**Submitted by the experts from
the Republic of Korea**

Informal document GRSG-128-08
GRSG 128th session, 7-11 October 2024
Agenda Item 2

Question of UN R107

◆ Case 1

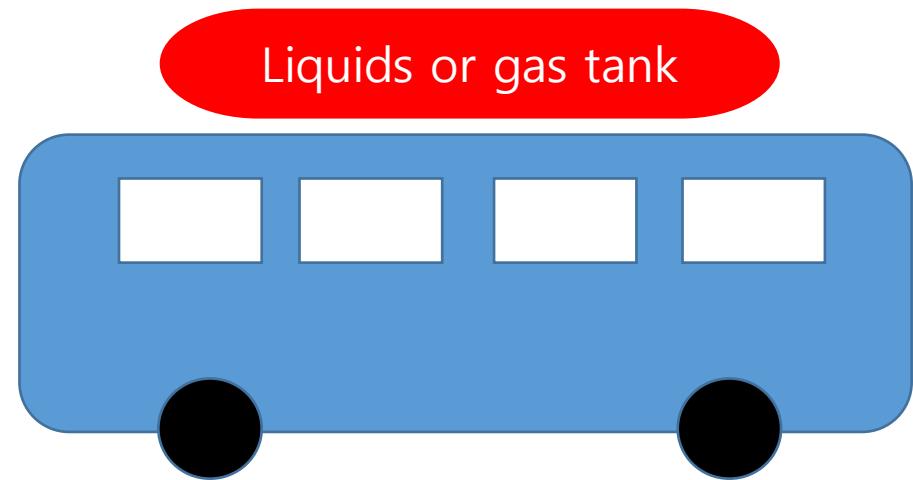
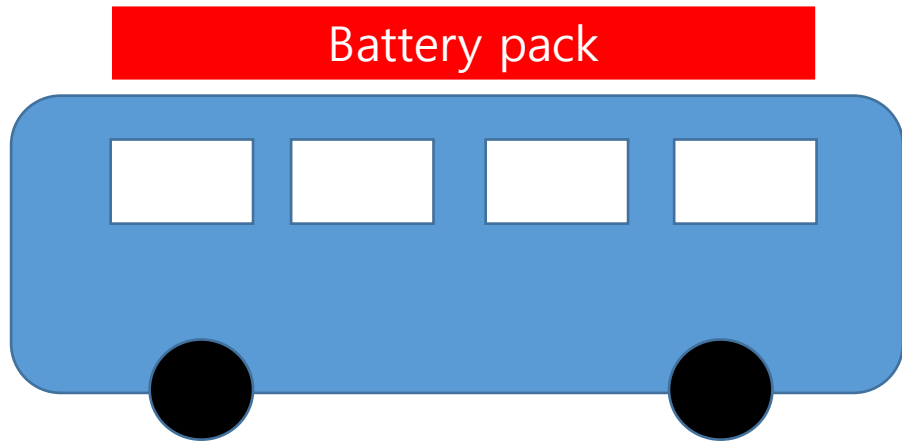
- Bus design with some tanks on its roof
- There is no place to install a escape hatch or escape hatches

◆ Case 2

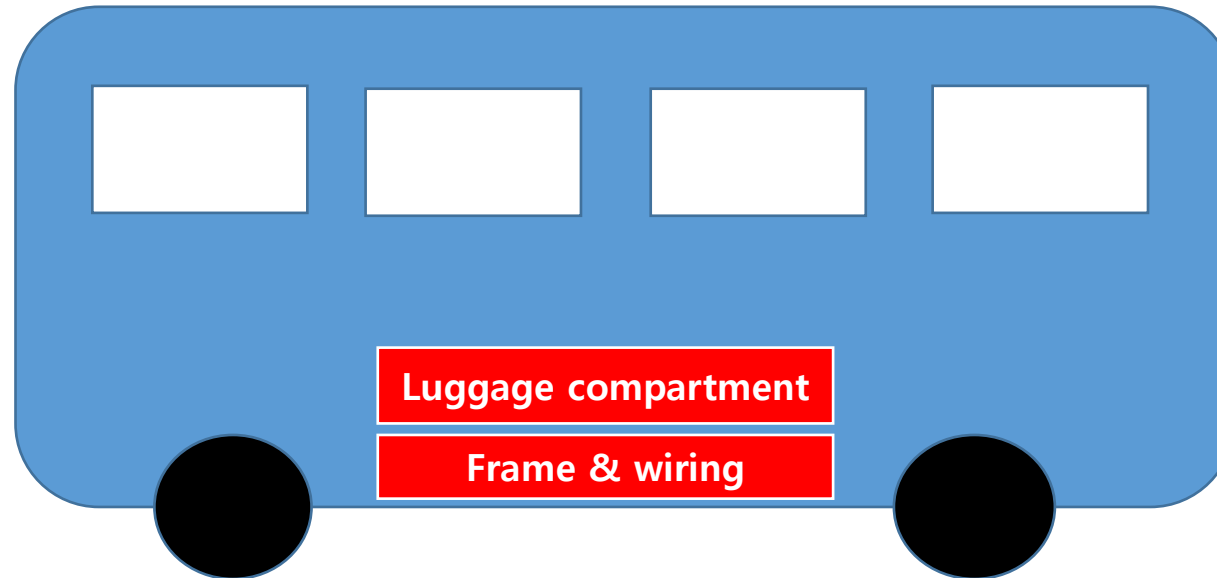
- Bus design with some electric equipments or wiring on its bottom
- There is no place to install a escape hatch or escape hatches

- In the case of 7.6.1.12. , can it be interpreted as allowing for the exclusion of the installation?
- If installation on the roof is not possible, is it appropriate to install two emergency exits on the floor in accordance with 7.6.2.8.?
 - ✓ If installing on the floor, both the passenger area floor and the luggage compartment must be taken into consideration simultaneously.
 - ✓ Structural integrity may be weakened due to modifications to the existing lower frame.
